MANDATORY SERVICE BULLETIN Z 50/42a AND Z 50M/14a

1. **DATE:** May 25, 1998
2. **MODELS AFFECTED:** All Z 50L, Z 50LA, Z 50LE, Z 50LS, Z 50LX and Z 50M aircraft.
3. **SUBJECT:** Occurrence of damage of riveted joint of the foot control cable suspensions at the rudder.

Fig. 1: View of the rudder upwards

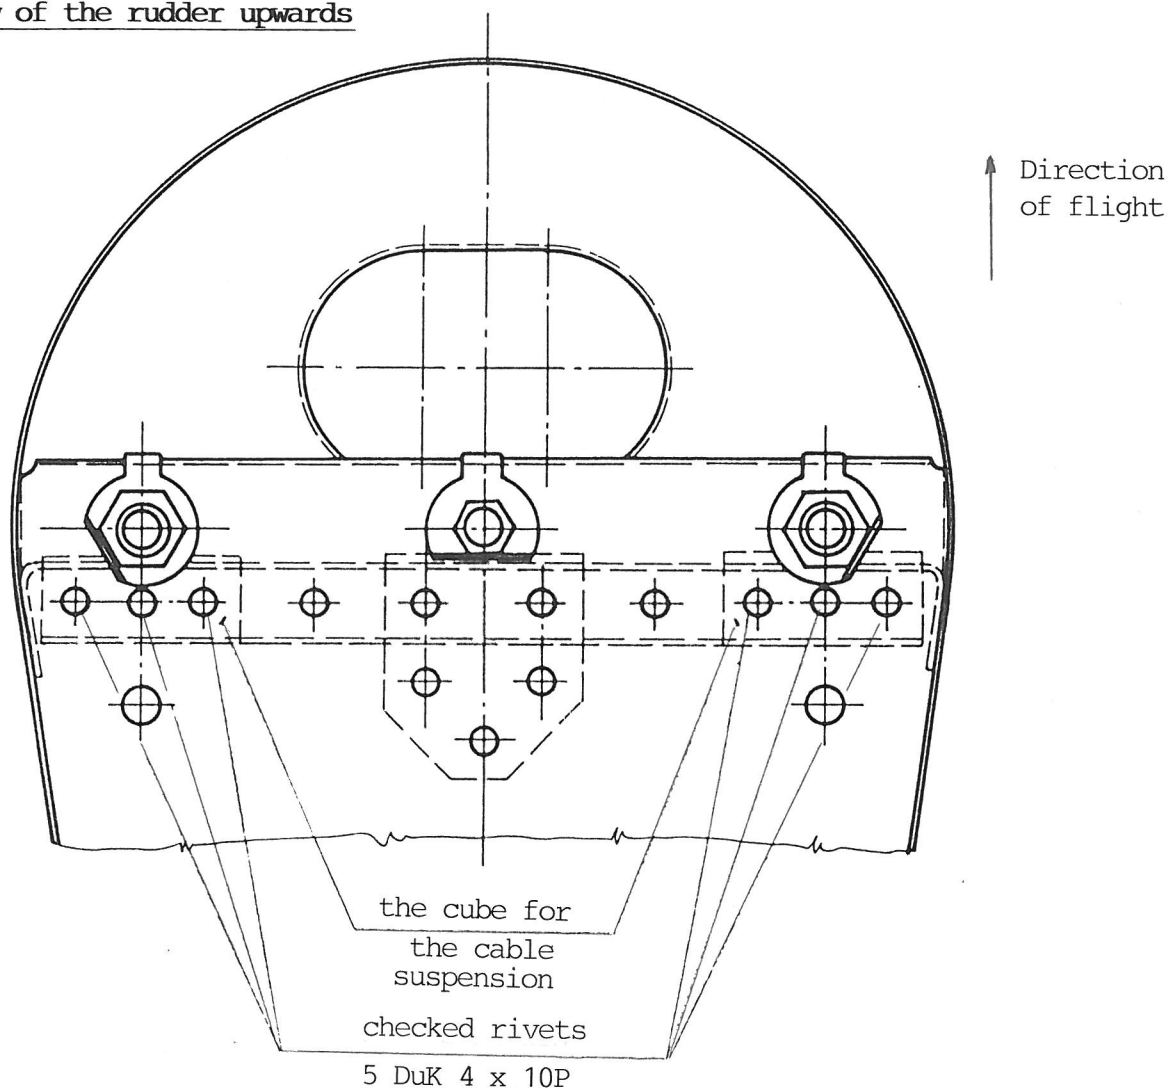
a) damage (loosening or cutting-off) of the rivets by means of which the cubbes for the cable suspensions of the foot control are fastened (Fig. 1);

Either loosened or cut off rivets according to the point a) or undue diameter according to the point b) are inadmissible. If you find out the damage according to the point a) or using the undue rivet diameter according to the point b) accomplish working procedure described in the Service Instruction No. 5 (Enclosure 2 of this bulletin).
